Technical Note

Project:	P21-184 Littlestone, Kent		
Subject:	Technical Note – LLFA Response to Overland Flow Routing		
Prepared by:	Ben McManus – Project Engineer	Date:	13th April 2022
Authorised by:	Nick Fenton – Associate	Status:	S2 - Information
Document Ref:	0058-RLL-00-XX-TN-C-002	Revision:	P04

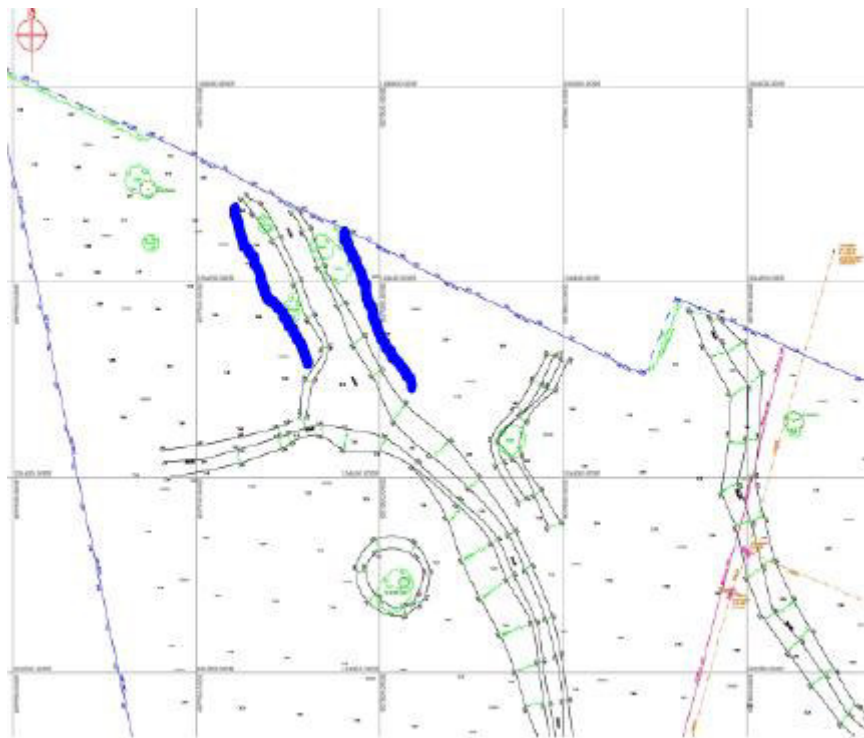
Residents Association have expressed concerns regarding the infill of a ditch on the northern boundary of the site. The below is a snippet taken from the Topographical Land Survey and shows the ditch's relative position (highlighted in a blue outline). The LLFA have also received photographs from the Residents Association that have shown this feature holding and conveyancing surface water runoff from the surrounding land.

At the most northern part of the ditch shown above the base level is 2.30 mAOD, which falls in a south easterly direction to a level of 1.89 mAOD in the centre of the site (see Appendix A). Based on the FRA that was undertaken by Herrington Consulting Ltd and as shown on the Overland Flow Routing drawing (Appendix B) ditch A at the northern part of the site is to be enhanced. Currently, it is believed that the feature shown above is holding surface water runoff that overtops from ditch A due to capacity limitations in the pipe network that leaves the north-eastern corner of the site. Therefore, the intention of the proposed ditch A overflow is to convey flows through the site without ponding within localised low alleviating the problem described above.

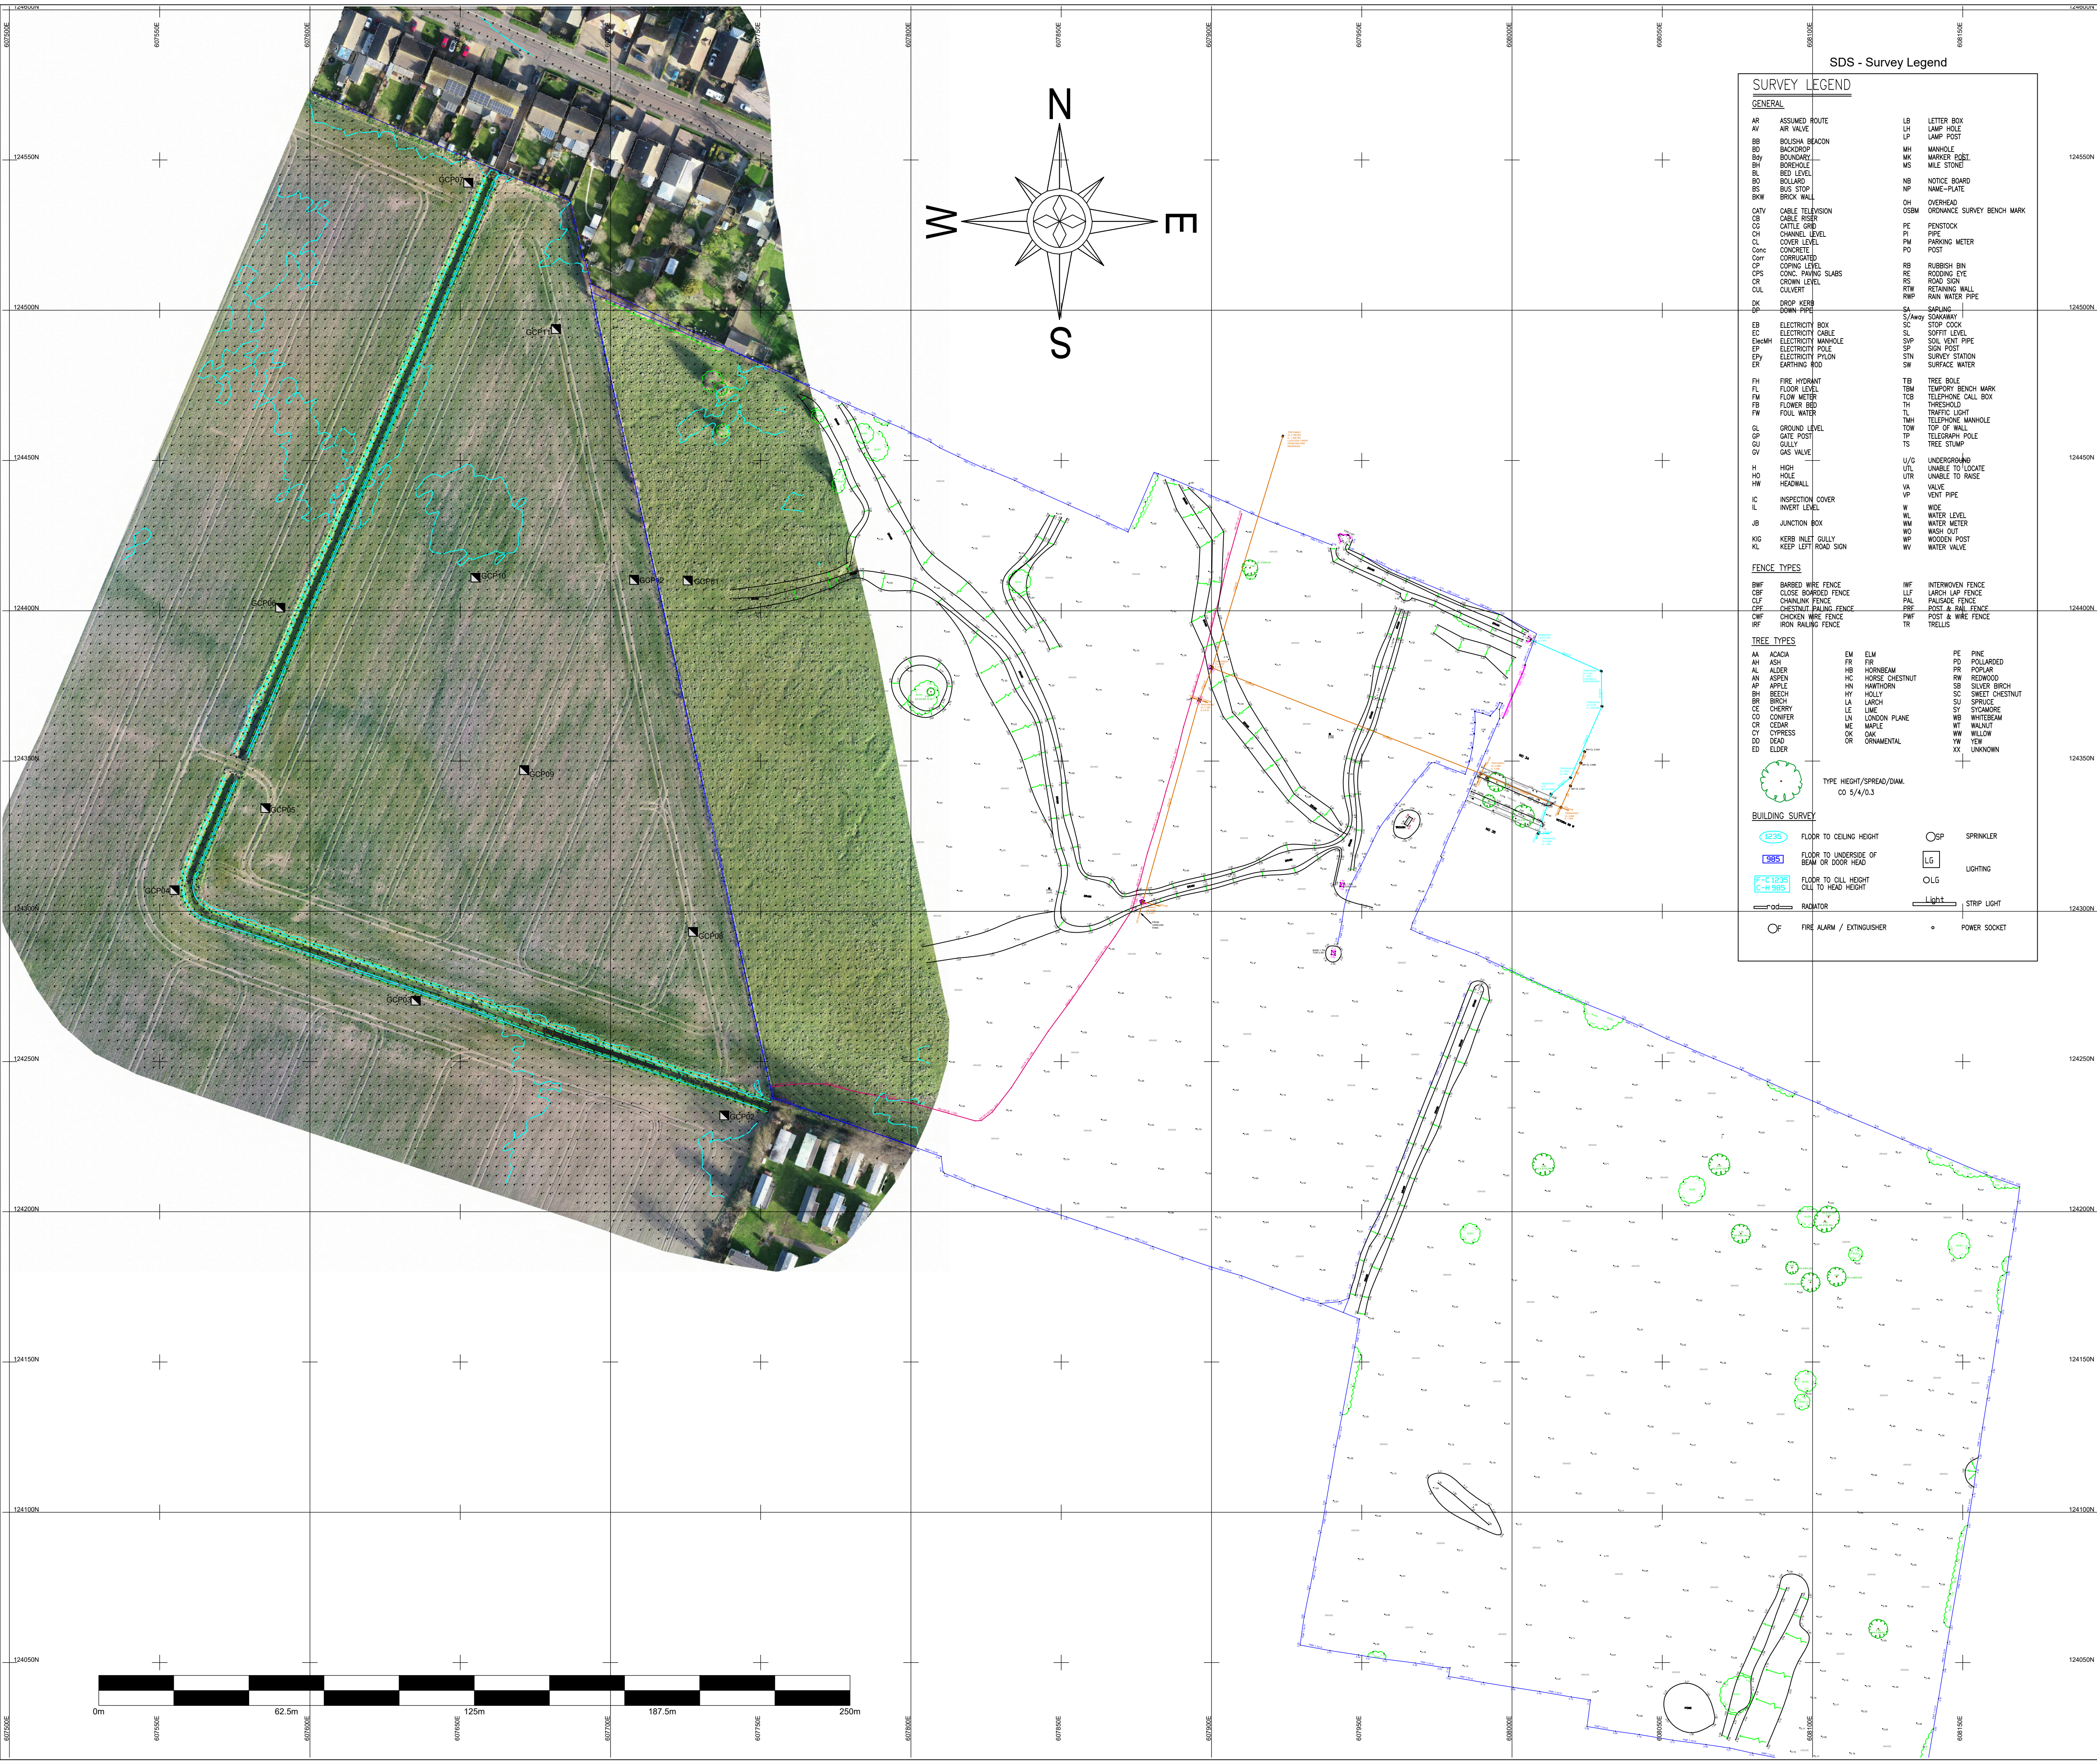
In addition to the above, our previous consultation response sent on the 1st of September 2021 raised queries regarding the proposed land raising on site, specifically in relation to rear garden properties adjacent to existing rear gardens along Queens Road. We would note that this appears to remain unaddressed, and we would seek that this is also clarified.

Due to the site being within a flood zone it was recommended that all buildings at risk were raised a minimum of 300mm above the existing level. As noted, we are raising the land more than this and this has been proposed as a solution for this site due to the shallow nature of groundwater and underlying strata, which tends to be running sands. It is also about the constructability and safety of the construction workers that will be working on this site.

As shown on the Overland Flow Routing drawing we are proposing the inclusion of land drainage in the rear gardens of the properties described, which will connect into ditch A as to prevent any runoff entering the existing properties gardens.
